University of South Carolina – Columbia, SC Campus
707 Catawba St -Fire Protection Upgrades
Proj No. H27-Z409 50003813-3
Addendum #2

ADDENDUM NUMBER 2

1.02 PROJECT: Fire Protection Upgrades – 707 Catawba St Student Center
Fire Sprinkler Retrofit in Existing Building

3.02 DRAWINGS

ADFS 1.0

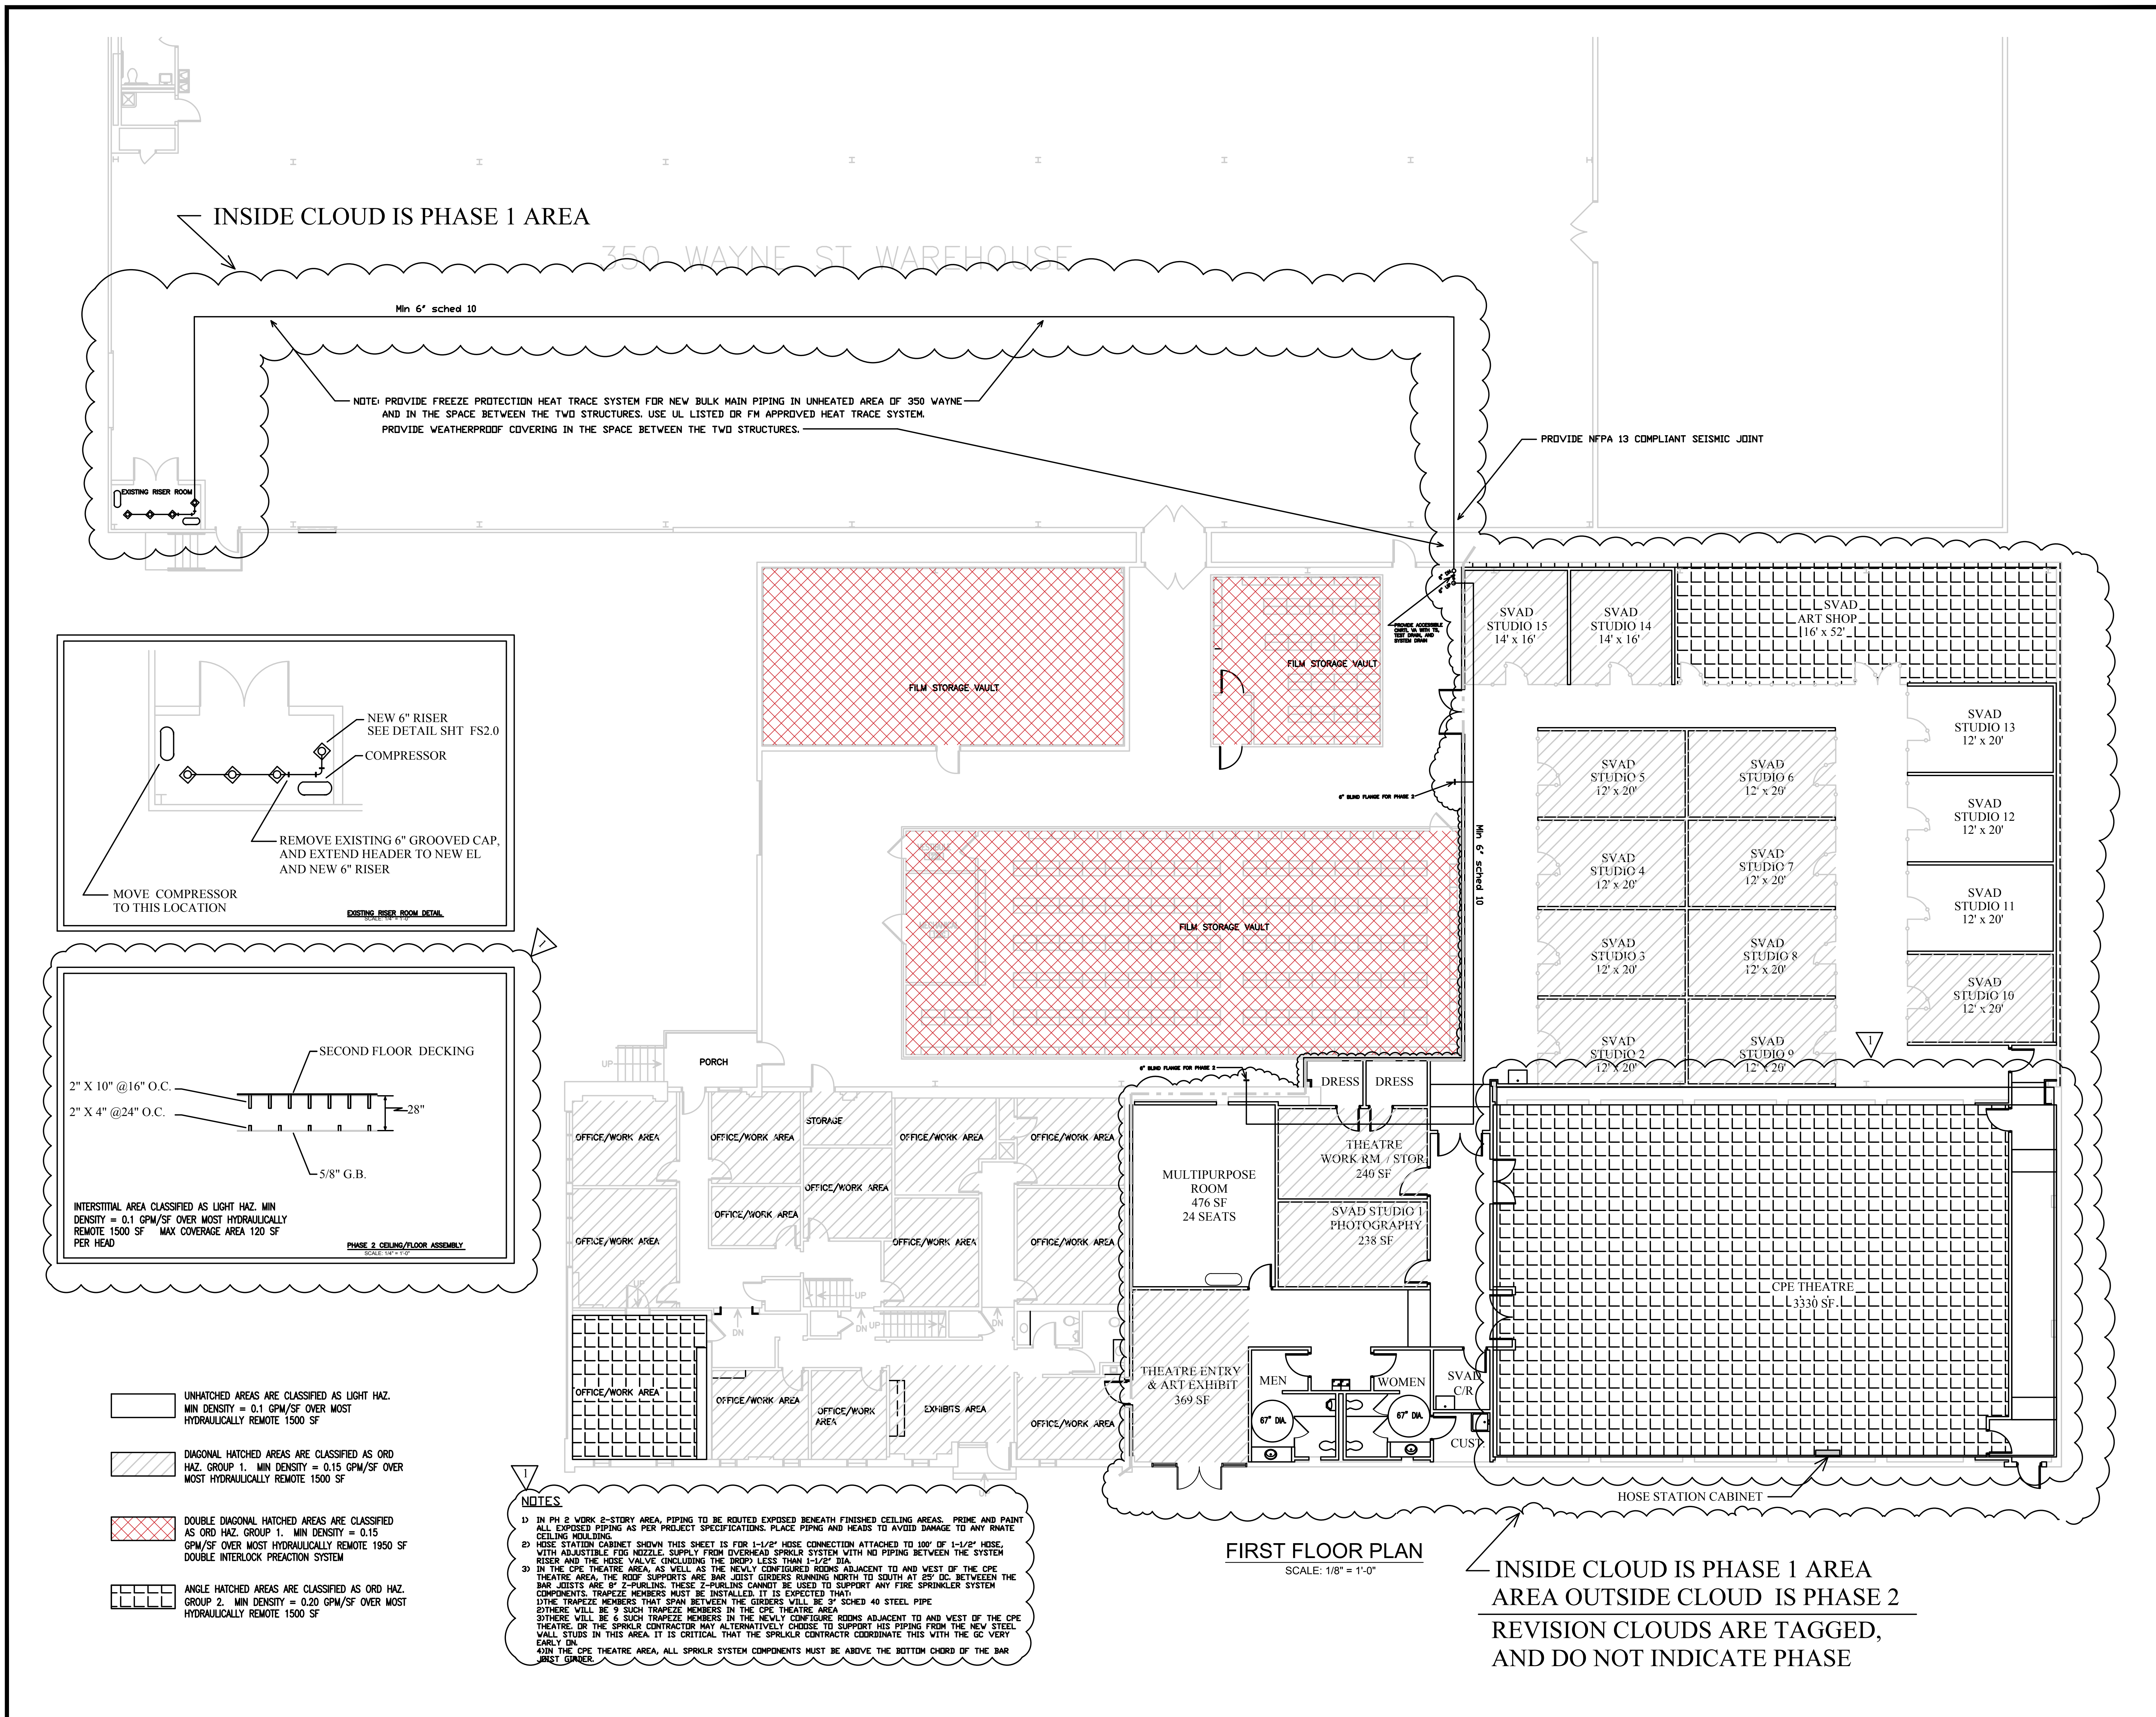
***Q5.** In the Phase 1 Work on dwg sheet ADFS-1.0, see the CPE Theatre, Theatre Work Room, Multipurpose Room, SVAD Studio 1, SVAD C/R, Theatre Entry and Art Exhibit, Restrooms and adjacent Corridor areas. In all these areas the roof supports are bar joist girders at 25'*

OC, and 8" Z-purlins at 5' OC. Is it acceptable to hang sprinkler piping from the Z-purlins?

Q6. *Is a hose station required at the CPE Theatre?*

Q7. *Is it acceptable to place the 3 preaction dry systems valves and trim at the point where the bulk main enters 707 Catawba from 350 Wayne?*

INSIDE CLOUD IS PHASE 1 AREA

- NOTES
- IN PH 2 WORK 2-STORY AREA, PIPING TO BE ROUTED EXPOSED BENEATH FINISHED CEILING AREAS. PRIME AND PAINT ALL EXPOSED PIPING AS PER PROJECT SPECIFICATIONS. PLACE PIPING AND HEADS TO AVOID DAMAGE TO ANY RIMATE CEILING MOLDING.

- HOSE STATION CABINET SHOWN THIS SHEET IS FOR 1-1/2" HOSE CONNECTION ATTACHED TO 100' OF 1-1/2" HOSE, WITH ADJUSTIBLE FOG NOZZLE. SUPPLY FROM OVERHEAD SPRINKLR SYSTEM WITH HD PIPING BETWEEN THE SYSTEM RISER AND THE HOSE VALVE (INCLUDING THE DROP), LESS THAN 1-1/2" DIA.

- IN THE CPE THEATRE AREA, AS WELL AS THE NEWLY CONFIGURED ROOMS ADJACENT TO AND WEST OF THE CPE THEATRE AREA, THE ROOF SUPPORTS ARE BAR JOIST GIRDERS RUNNING NORTH TO SOUTH AT 25' OC BETWEEN THE BAR JOISTS ARE 9" Z-PURLINS. THESE Z-PURLINS CANNOT BE USED TO SUPPORT ANY FIRE SPRINKLER SYSTEM COMPONENTS. TRAPEZE MEMBERS MUST BE INSTALLED. IT IS EXPECTED THAT THE TRAPEZE MEMBERS THAT SPAN BETWEEN THE GIRDERS WILL BE 3" SCHED 40 STEEL PIPE.

- THERE WILL BE 9 SUCH TRAPEZE MEMBERS IN THE CPE THEATRE AREA.
 - SYTHERE WILL BE 6 SUCH TRAPEZE MEMBERS IN THE NEWLY CONFIGURED ROOMS ADJACENT TO AND WEST OF THE CPE THEATRE. OR THE SPRINKLR CONTRACTOR MAY ALTERNATIVELY CHOOSE TO SUPPORT HIS PIPING FROM THE NEW STEEL WALL STUDS IN THIS AREA. IT IS CRITICAL THAT THE SPRINKLR CONTRACTOR COORDINATE THIS WITH THE GC VERY EARLY. DN.

- DN THE CPE THEATRE AREA, ALL SPRINKLR SYSTEM COMPONENTS MUST BE ABOVE THE BOTTOM CHORD OF THE BAR JOIST GIRDERS.

A5. No, the roof Z-purlins are incapable of supporting any fire sprinkler system loads whatsoever. It is expected that the main lines in these areas will be routed adjacent to the north and south CMU walls of this area, where the mains may be supported with brackets attached to these CMU walls, as well as the bar joist girders that are 25' OC. The branch lines in the CPE Theatre area may be supported by intermediate trapeze-type members that span the 25' between the bar joist girders, as well as the bar joist girders themselves. Sprinkler contractor must coordinate with the general contractor to identify the location and loading of these trapeze-type members, to determine the necessary panel point modifications to the bar joist girders. General contractor will provide modifications (panel points) as necessary to the existing bar joist girders, and sprinkler contractor will provide and install the trapeze-type members. It is expected that:

- * the trapeze members that span the 25' from girder to girder will be will be 3" dia sched 40 steel pipe
- *there will be 9 total such trapeze hangers required in the CPE Theatre area, 3 in each bay
- * all piping and heads in the CPE Theatre area must be above the bottom chord of the existing bar joist girders
- * there will be 6 total such trapeze hangers required in the Theatre Work Room, Multipurpose Room, SVAD Studio 1, SVAD C/R, Theatre Entry and Art Exhibit, Restrooms and adjacent Corridor areas, 3 in each bay.
- * all this must be coordinated with the GC very early on

A6. Yes, a 1-1/2" hose connection is required, supplied from the overhead sprinkler system, with no piping supplying the hose station (including the drop) to be less than 1-1/2". Provide hose cabinet with 100' of 1-1/2" hose and adjustable fog nozzle at the location shown on Dwg Sheet ADFS-1.0.

A7. Yes. The 3 preaction dry systems valves and trim may be placed in the corridor between the film storage vault and the SVAD STUDIO 15 on the system side of the building entrance control valve on a dropdown loop shown on Dwg Sheet ADFS-1.0. But for purposes of bidding, these 3 preaction dry systems valves and trim are still to be considered phase 2 work.

ADFS 2.1

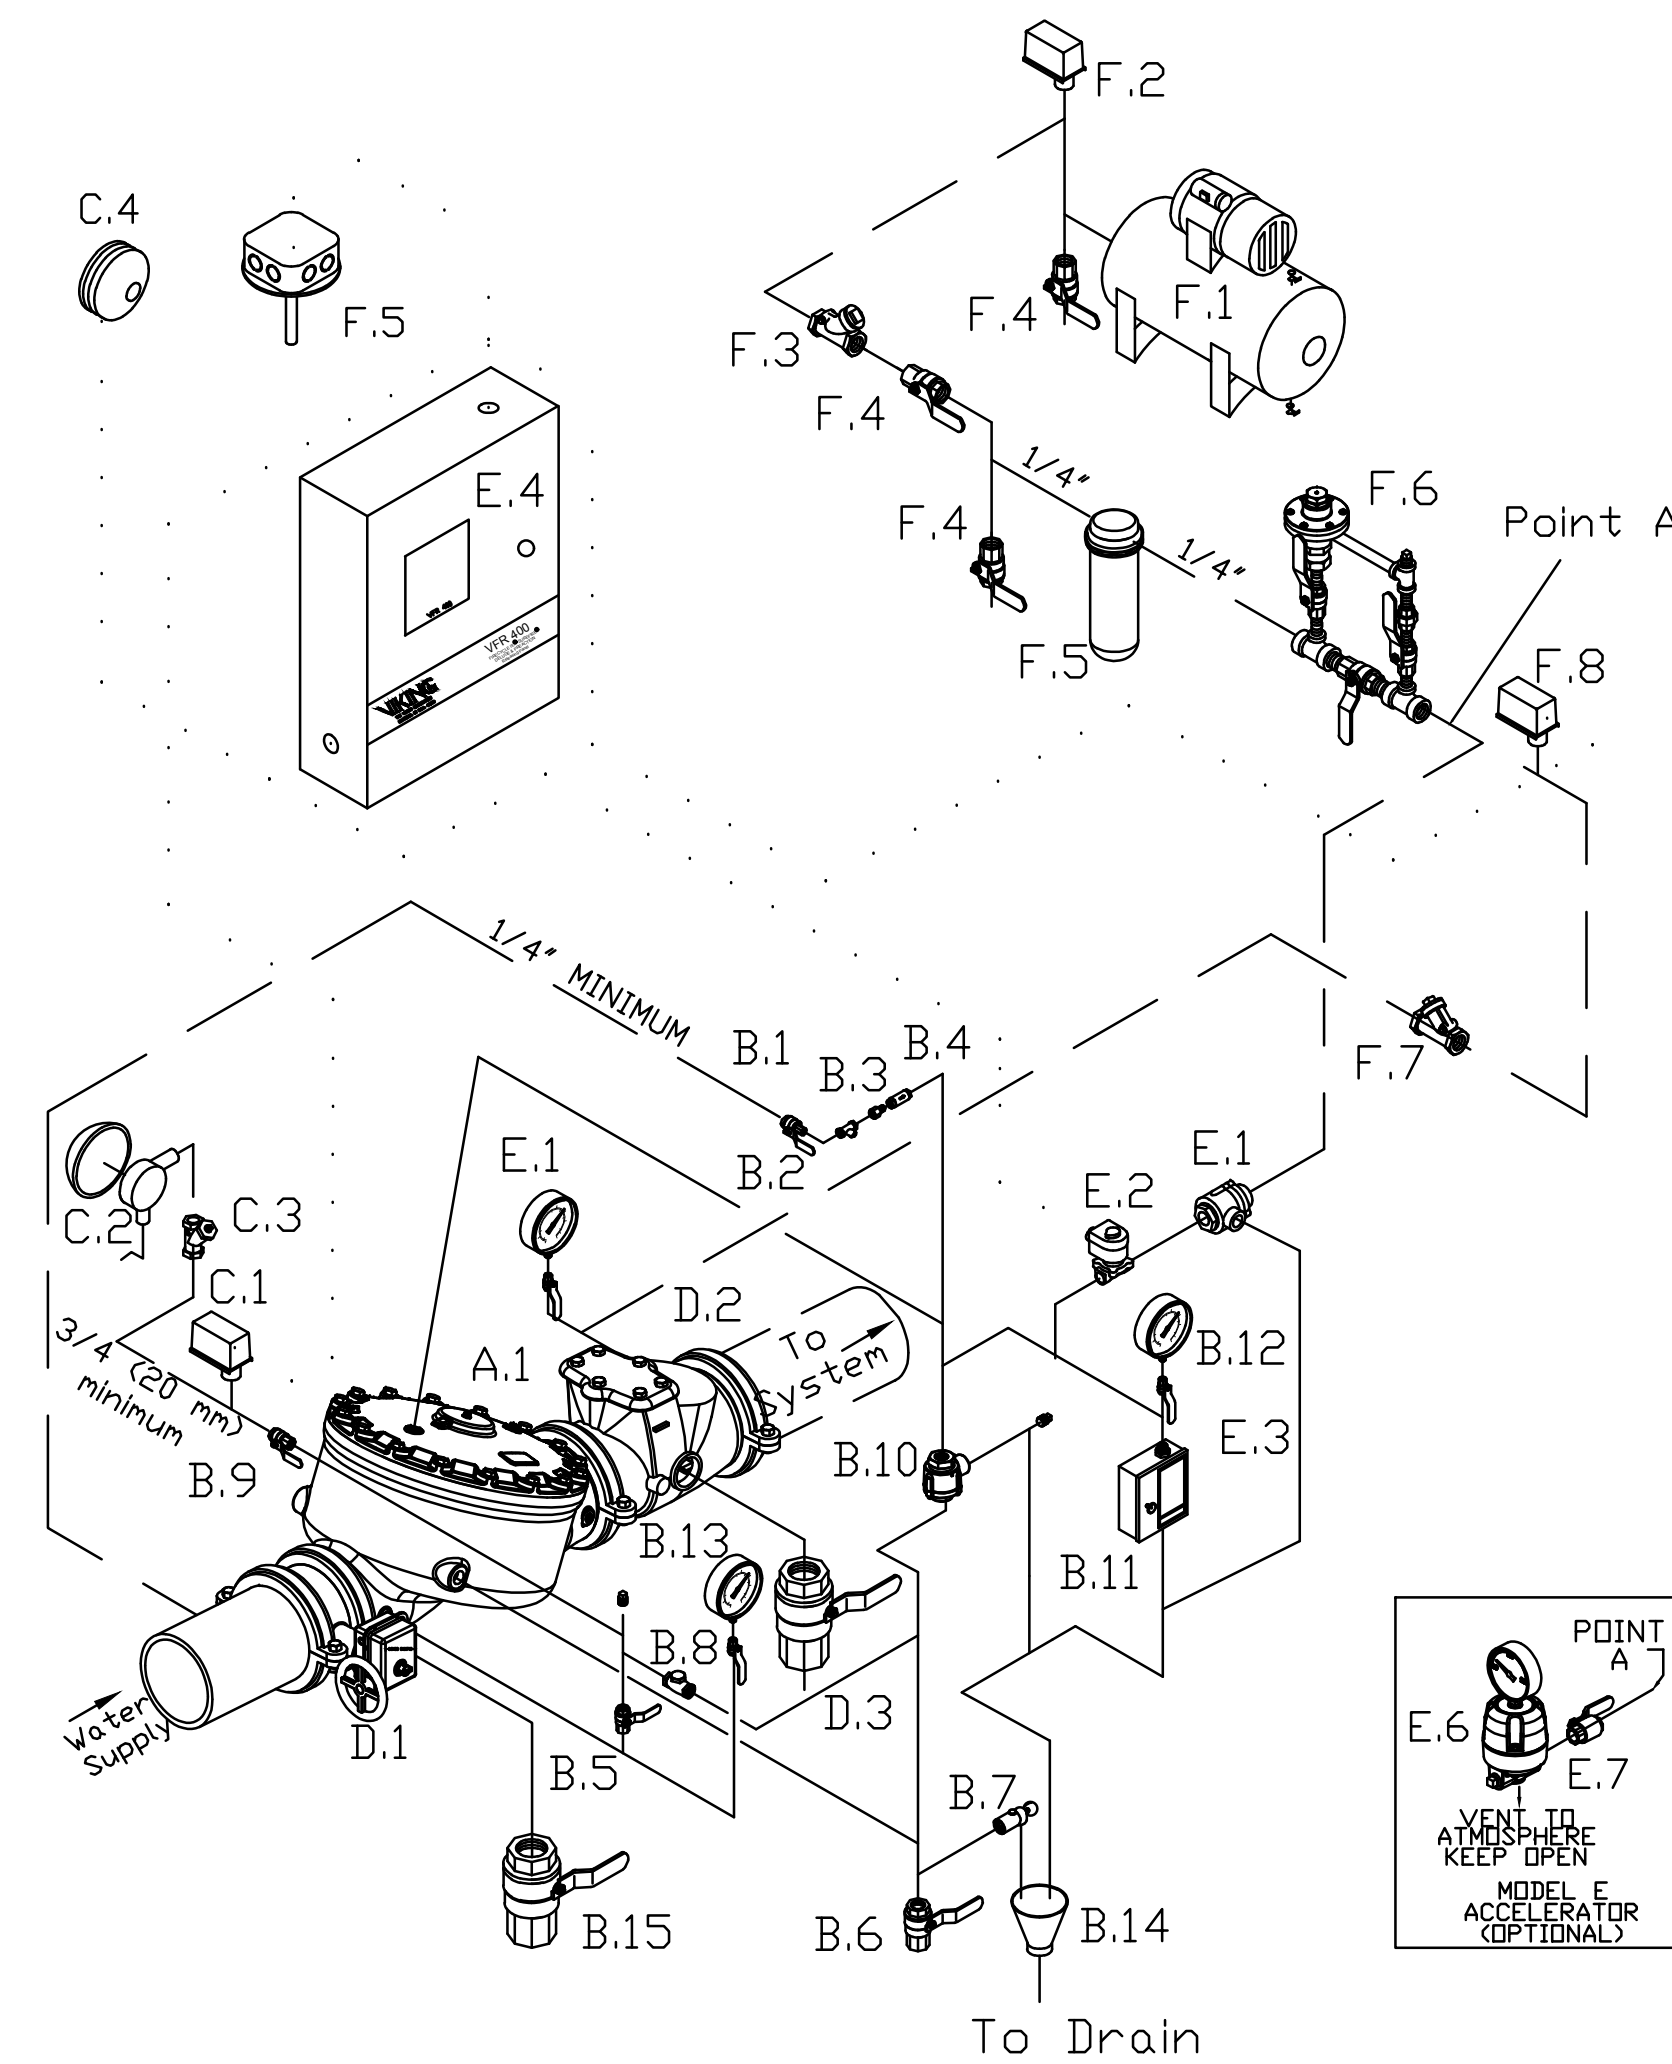
***Q1.** Is it acceptable to use detecto-wire in lieu of heat detectors inside the storage vaults?*

***Q2.** For the two factory-built film storage vaults, is it acceptable to route the dry piping above the ceiling/roof of these vaults, and use special dry-type pendant sprinkler heads in the vault, each sprinkler head supplied by a separate drop through the ceiling?*

- 1) FIRE SPRINKLER CONTRACTOR IS TO PROVIDE COMPLETE AND SEPERATE DOUBLE INTERLOCK PRE-ACTION SYSTEMS IN THE 3 VAULTS AS SHOWN, INCLUDING ALL COMPONENTS OF THE DELUGE VALVE ELECTRONIC ACTIVATION SYSTEM-INCLUDING INSIDE VAULT HEAT DETECTORS, ELECTRICAL PANELS, CONDUIT AND WIRING, AND VAULT FA NOTIFICATION DEVICES. POWER TO THE PANELS WILL BE PROVIDED BY THE ELECTR CONTRACTOR, CONTACT ALARM DESIGNER FOR POWER SUPPLIES AND INTERFACES WITH THE BLDG FIRE ALARM SYSTEM.

- 2) PROVIDE NITROGEN-BASED CORROSDION CONTROL FOR ALL PRE-ACTION DRY SYSTEMS PIPING (NOT SHOWN).
- 3) PROVIDE INTERNALLY AND EXTERNALLY GALVANIZED PIPING AND FITTINGS FOR ALL PRE-ACTION DRY SYSTEMS PIPING

- 4) PROVIDE SRKLR GUARDS FOR ALL HEADS LESS THAN 7' ABOVE F.F.
- 5) PROVIDE MODULE IN EACH PREACTION PANEL THAT WILL NOTIFY THE BLDG MAIN FA PANEL AS TO WHICH VAULT SYSTEM IS IN ALARM, SO THAT INFO IS ANNUNCIATED BY THE MAIN PANEL.

A1. Yes, that is the contractors option. All parts of the detection system must be installed in full compliance with NFPA 72, NFPA 70, UL listing conditions, and manufacturers recommendations.

A2. Yes, this is acceptable if each drop penetration through the vault ceiling/roof annular space is sealed in accordance with the vault manufacturer's recommendations.
